BIRMINGHAM CITY COMMISSION
SPECIAL LAND USE PERMIT AMENDMENT

SUBJECT: **Public Hearing for Final Site Plan & Special Land Use Permit Amendment at 33588 Woodward – Shell Gas Station (Former Citgo)**

SUBJECT: **Special Land Use Permit and Final Site Plan Review - 33588 Woodward – Shell Gas Station (formerly Citgo)**

FINAL SITE PLAN

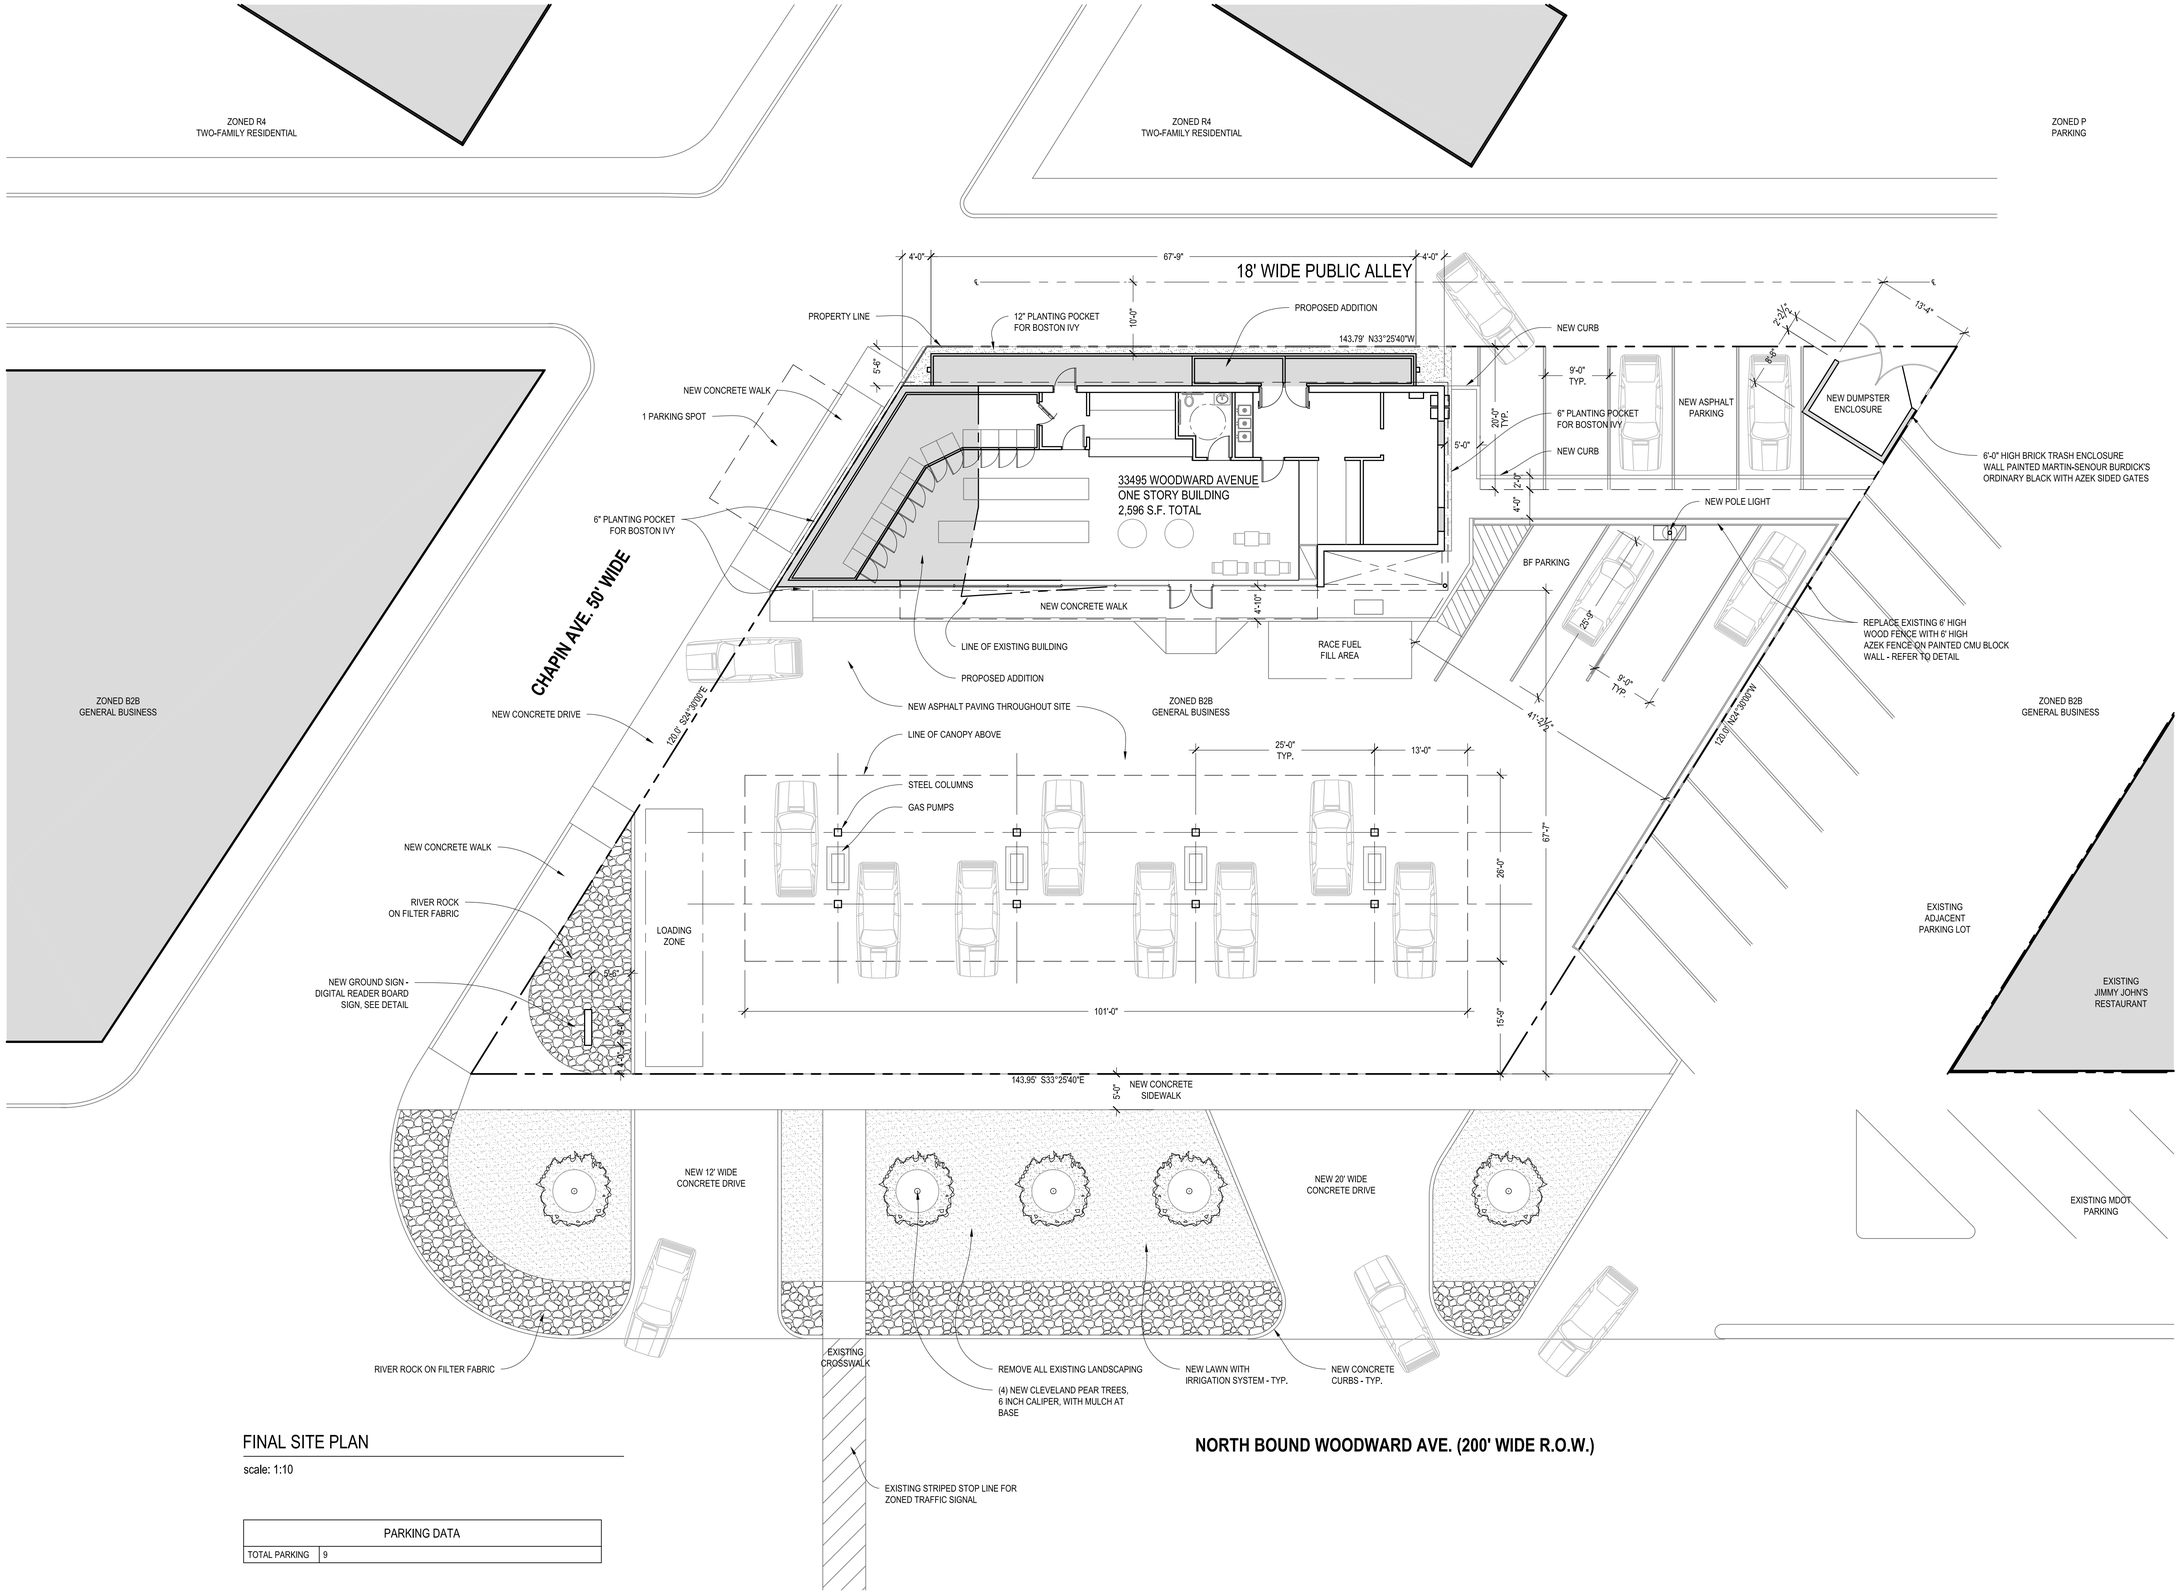
1. The plan proposes relocation of the drive approach on to Chapin Ave. All work relative to replacing sidewalks and curbs at the existing drive locations, as well as modifying the sidewalk for the new location, shall be required to be included in the final plans approved for construction.

2. On the Woodward Ave. side, the existing pavement in the area of the drive approaches is in poor condition. It is expected that the new approaches shown will be completely new pavement, up to and including what is needed to make a new transition with the right-of-way parking lot to the south.

3. The large existing shrubs located in the Woodward Ave. right-of-way are a sight distance hazard, and need to be removed as a part of this renovation.

1. It appears that the "Racing Fuel Pump" may be located to close to the building and the overhang. All Pumps shall comply with section 2203 of the International Fire Code.

2. Dispensing devices shall be in clear view of the attendant at all times. Due to the location of the pumps and the check-out area at the back of the store, some pumps may be blocked from attendants view. View of pumps shall comply with section 2204 of the International Fire Code.

SITE PHOTOMETRIC PLAN

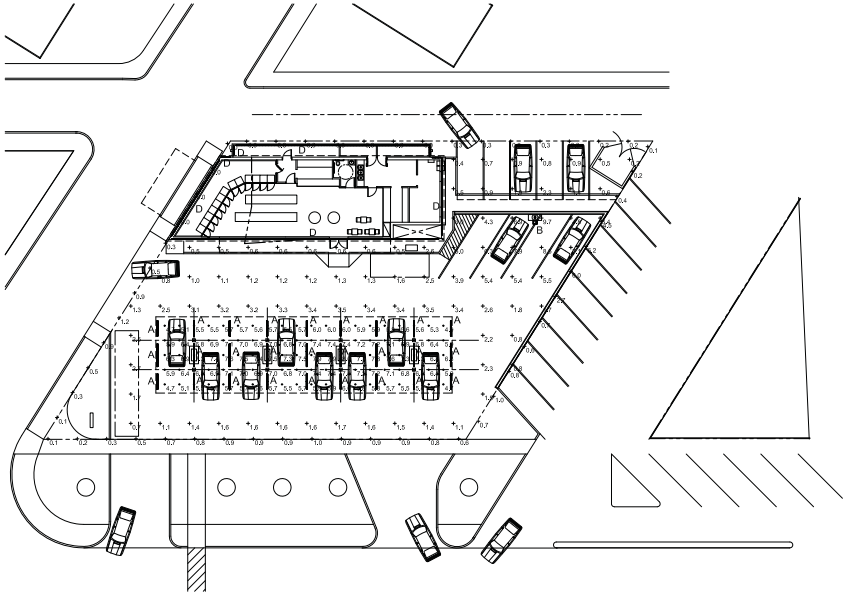
Site lighting
The plan indicates compliance with the lighting standards of section 4.21 LT-01 of the Zoning Ordinance in regards to the light trespass levels, cut-off fixtures, and Illuminance levels under the Canopy. However, the max/min foot-candle ratio of 48.5/1 exceeds the levels permitted in the ordinance. **The applicant must reduce the max/min foot-candle levels in the parking/drive area to 20/1 or obtain a variance from the Board of Zoning Appeals.**

The Planning Board may wish to consider eliminating the up lighting on the back of the building which faces the single-family residential zone.

1. The applicant must reduce the max/min foot candle levels in the parking/drive area to 20/1 or obtain a variance from the BZA;
2. The applicant addresses all department concerns as outlined in the report subject to administrative approval;
3. All mechanical equipment must be fully screened;
4. The Planning Board approves the use of non-cutoff fixtures to up light the facade as proposed tonight;
5. Full brick is allowed and permitted as indicated tonight.
